# UNITED STATES PATENT AND TRADEMARK OFFICE

APPLICATION NO.	FILING DATE	FIRST NAMED INVENTOR	ATTORNEY DOCKET NO.	CONFIRMATION NO.
10/780,444	02/17/2004	Peter M. Bonutti	782-A03-023	2789
33771	7590	07/07/2009		
PAUL D. BIANCO Fleit Gibbons Gutman Bongini & Bianco PL 21355 EAST DIXIE HIGHWAY SUITE 115 MIAMI, FL 33180			EXAMINER SZPRA, JULIE ANN	
			ART UNIT	PAPER NUMBER
			3731	
			MAIL DATE	DELIVERY MODE
			07/07/2009	PAPER

### Office Action Summary

**DETAILED ACTION**

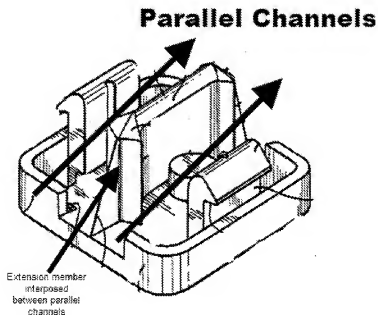
5. **Claims 1-8, 19, 24 and 50-53** are rejected under 35 U.S.C. 102(b) as being anticipated by **Merritt (US 5,208,950)**.

**Regarding claim 1**, Merritt discloses a device that is capable being implanted and securing an object relative to a body tissue (cord lock, 10) comprising a first (male body, 14) section including a first surface (54) and an extension member (projection, 66) extending from that surface, and a second (female body, 12) section including a second surface (34) opposing the first surface and being configured for receiving the extension member (recess, 35), the first and second section being bondable together with the application of an energy source (ultrasonic welding; column 4, lines 35-36).

**Regarding claim 4**, Merritt discloses the first section including a pair of parallel channels (Figure 4, see below).

**Regarding claim 5**, Merritt discloses the extension member (66) interposed between the pair of parallel channels (Figure 4, see above).

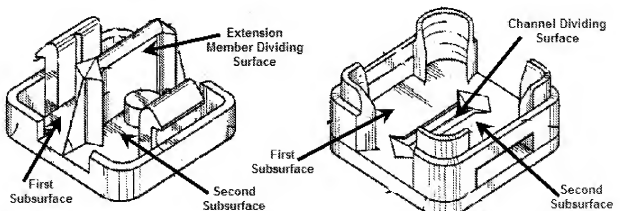
**Regarding claim 50**, Merritt discloses the first section has two channels (76) formed therein, said channels being disposed opposingly about and immediately adjacent to said extension member and the second section is configured to seat within the channels of the first section (Figure 3).

**Regarding claim 51**, Merritt discloses said extension member divides said first surface into a first first-surface subsurface and a second first-surface subsurface, a channel divides said second surface into a first second-surface subsurface and a second - surface subsurface (See Figure Below), said first first-surface subsurface is configured to align with said first second-surface subsurface when said first section is bonded to said second section; and said second first-surface subsurface is configured to align with said second second-surface subsurface when said first section is bonded to said second section (Figure 3)

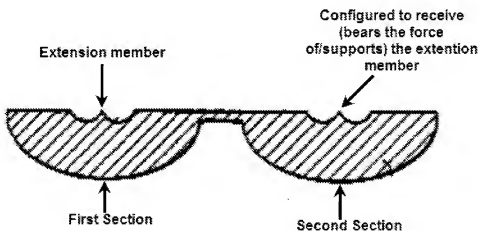
6. **Claims 1, 18, 49 and 54** are rejected under 35 U.S.C. 102(b) as being anticipated by **Egan (US 6,174,324)**.

**Regarding claim 1**, Egan discloses a device that is capable being implanted and securing an object relative to a body tissue comprising a first section including a first surface and an extension member extending from that surface, and a second section including a second surface opposing the first surface and being configured for receiving the extension member (See Figure Below) the first and second section being bondable together with the application of an energy source (ultrasonic energy; column 5, lines 23-37).

**Regarding claim 49**, Egan et al. discloses the first and second surfaces configured to sandwich the suture (Figure 12).
